# ADA Curb Ramp New Construction Inspection Form (Perpendicular)

Nw 292 ave

24952.54

Nw west union rd

## PERPENDICULAR RAMP (PR)

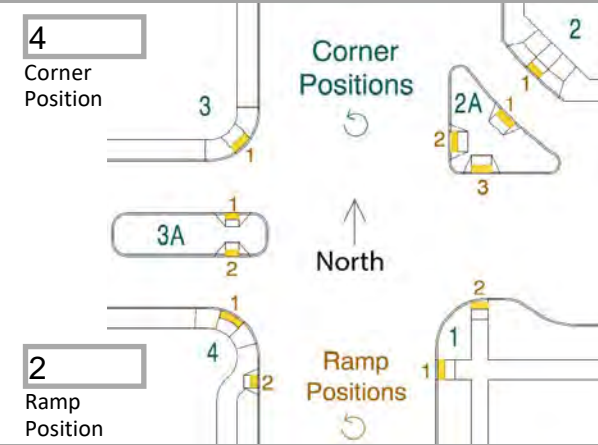
IITD not full width rr1 icrr turn space clear width less than 4'
